Product Change Notification / ALAN-18ICJA641

CCB 6236 Final Notice: Qualification of ANAP as an additional assembly site for ATMEGAxx, QT60168xx, ATTINY8xx, AT42QT11xx, AT89LP42xx, and AT42QT12xx device families available in 32L TQFP (7x7x1mm) package.

Pre and Post Change Summary

QUALIFICATION REPORT SUMMARY
RELIABILITY LABORATORY

LPI

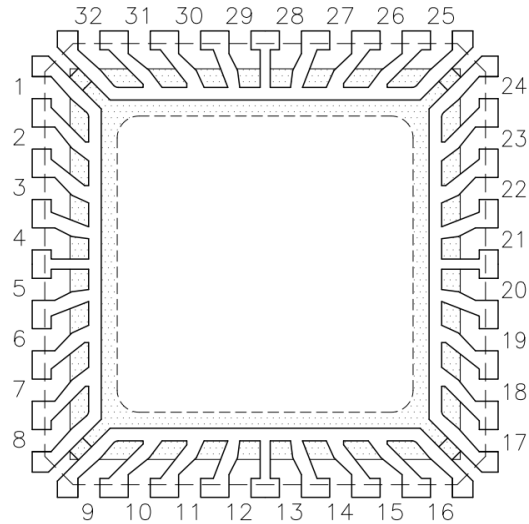
Wire Material	CuPdAu / Au
Die Attach Material	CRM-1033BF
Mold Compound Material	G700
Paddle Size	205X205
DAP Surface Prep	DOUBLE RING

MTAI

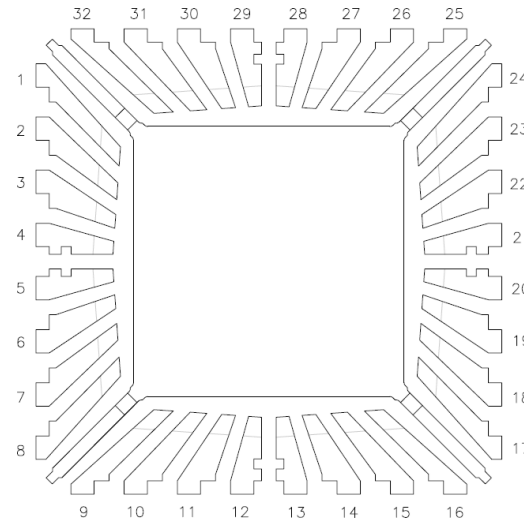
Wire Material	CuPdAu / Au
Die Attach Material	3280
Mold Compound Material	G700HA
Paddle Size	160X160
DAP Surface Prep	BARE Cu

ANAP

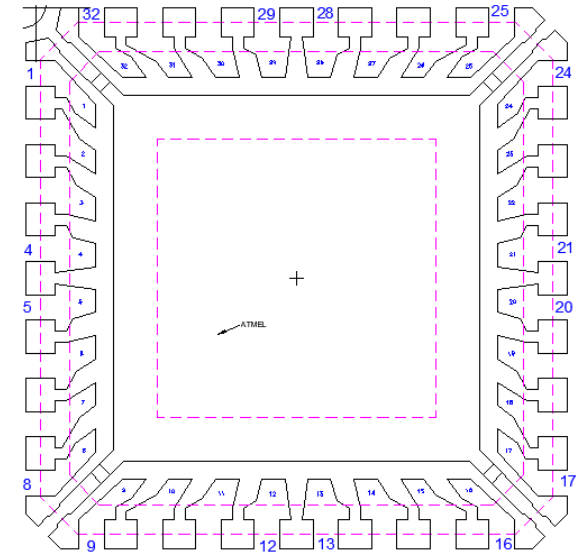
Wire Material	AuPd
Die Attach Material	3230
Mold Compound Material	G700L
Paddle Size	197x197 mil
DAP Surface Prep	DOUBLE RING
